Addendum #2

Attn: Estimator	Date: November 26, 2024
From: Lisa Donahue, Project Administrator	Pages: 25 (including cover page)
Re: Bullock Creek School District 2024 Bond Series 1	Project: 2025 Summer Projects HS/MS/Elem/Pine River/Floyd and Maintenance Building
CC:	Proj. #: A24907

ADDENDUM #2

Project: No. 24-120 2023 Bond – Series 1 2025 Improvements

DRAWING TITLE
MECHANICAL PARTIAL ROOF PLANS

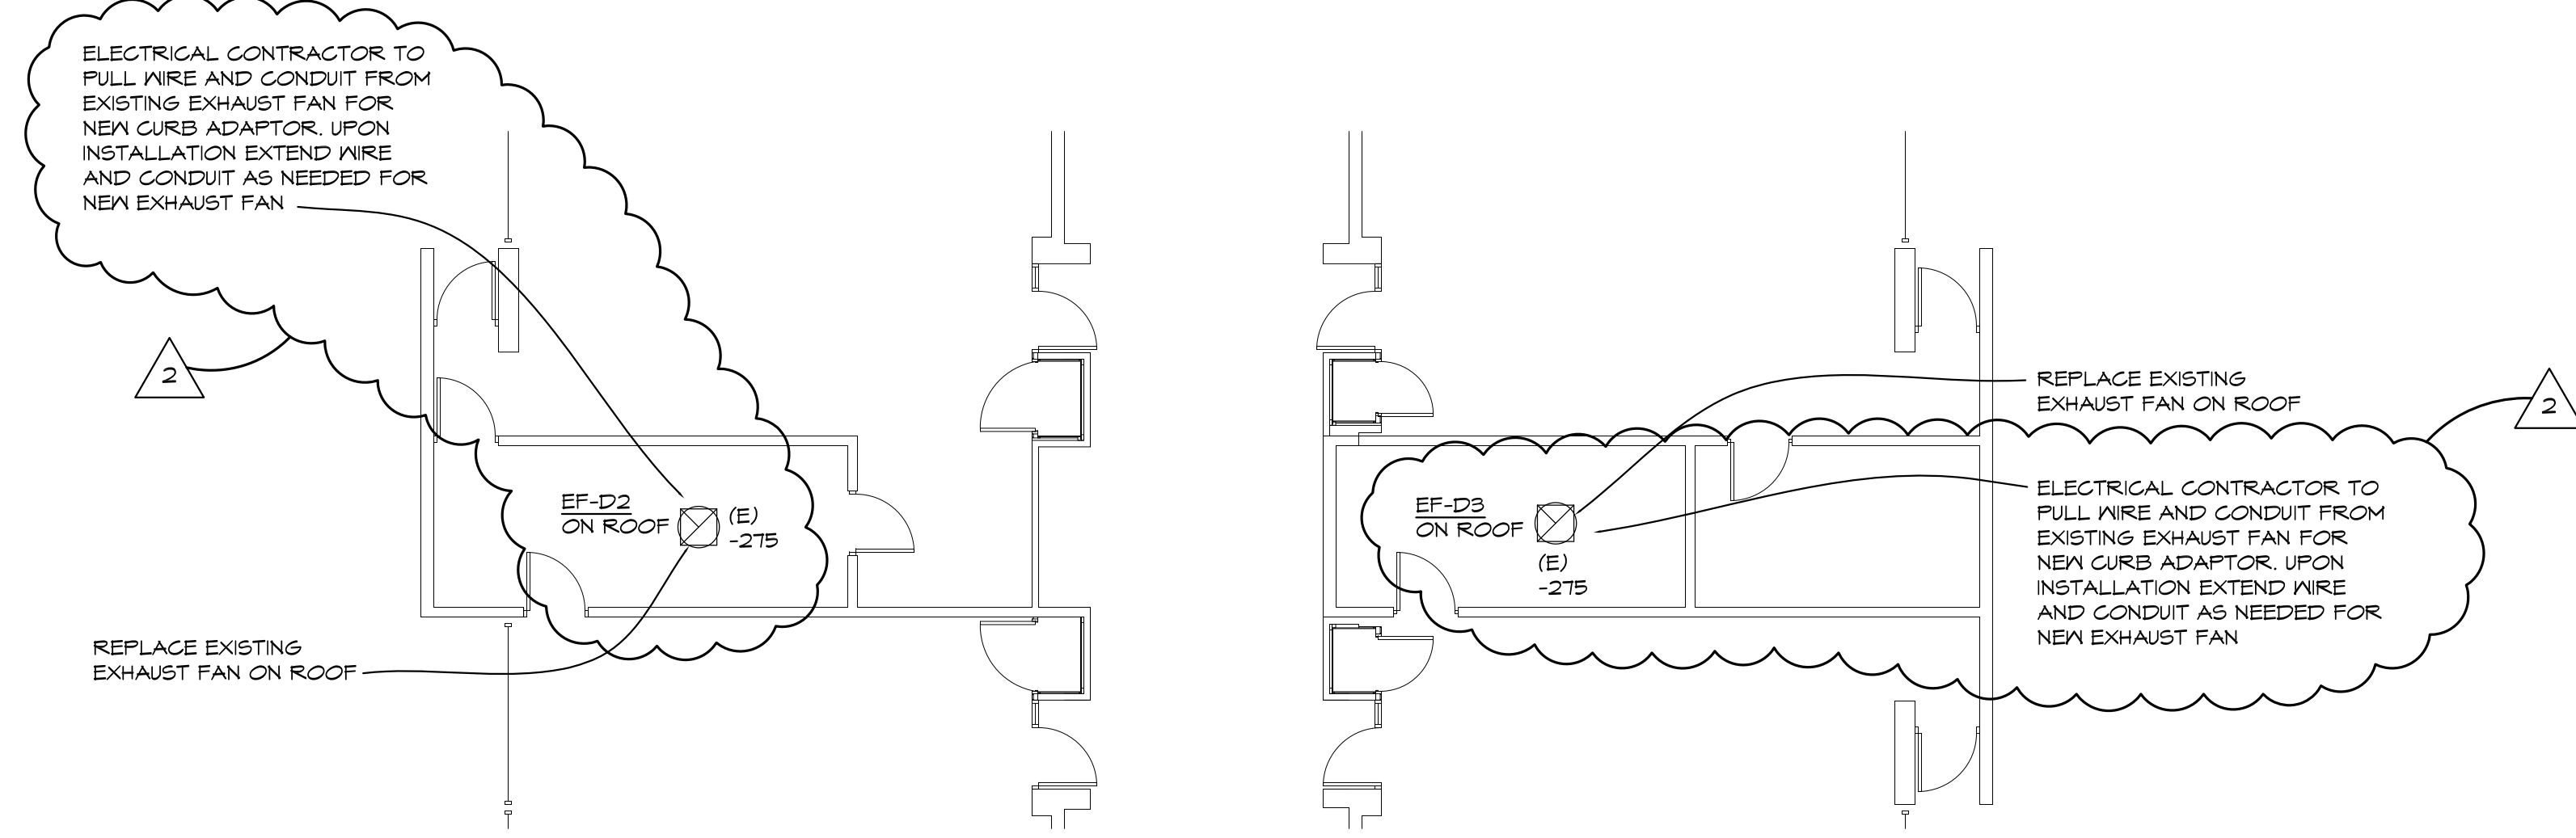
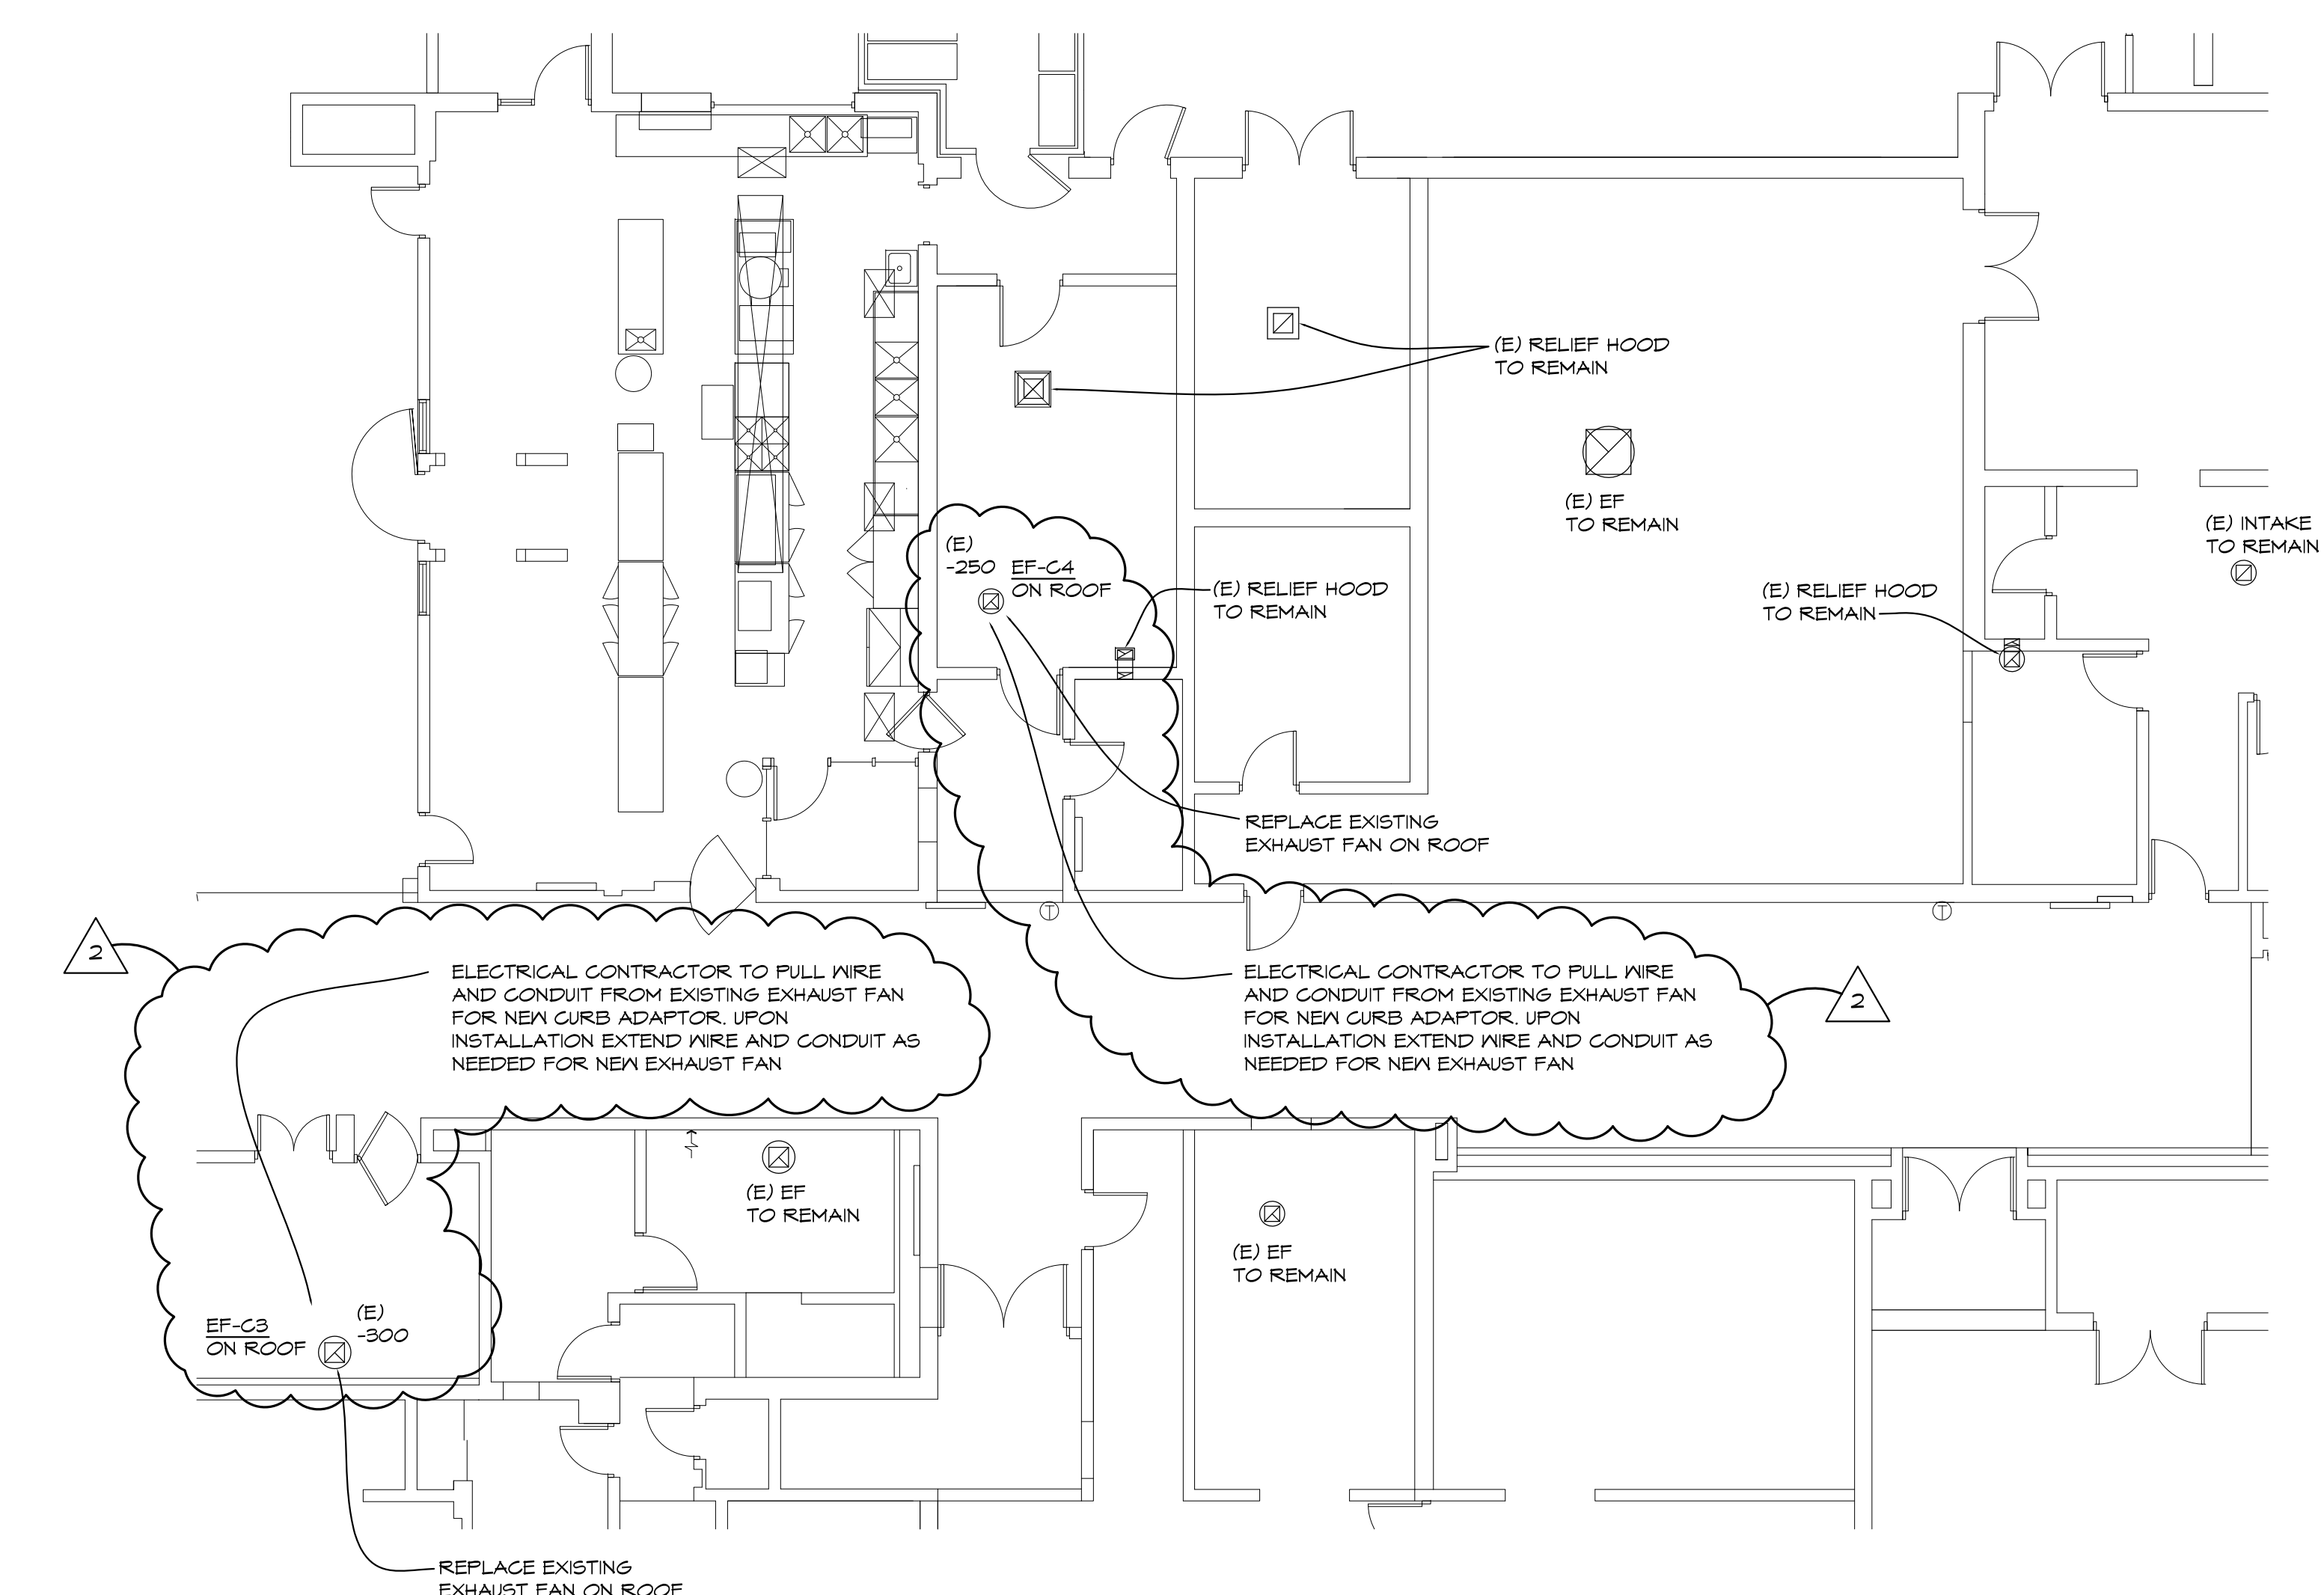
- Item #E1: Revise Sheet A-M102 as follows:
- a. Revise drawing number to be "A-ME102".
 - b. At exhaust fan replacement locations, pull wire and conduit from existing exhaust fan for new installation and extend wire and conduit as needed.
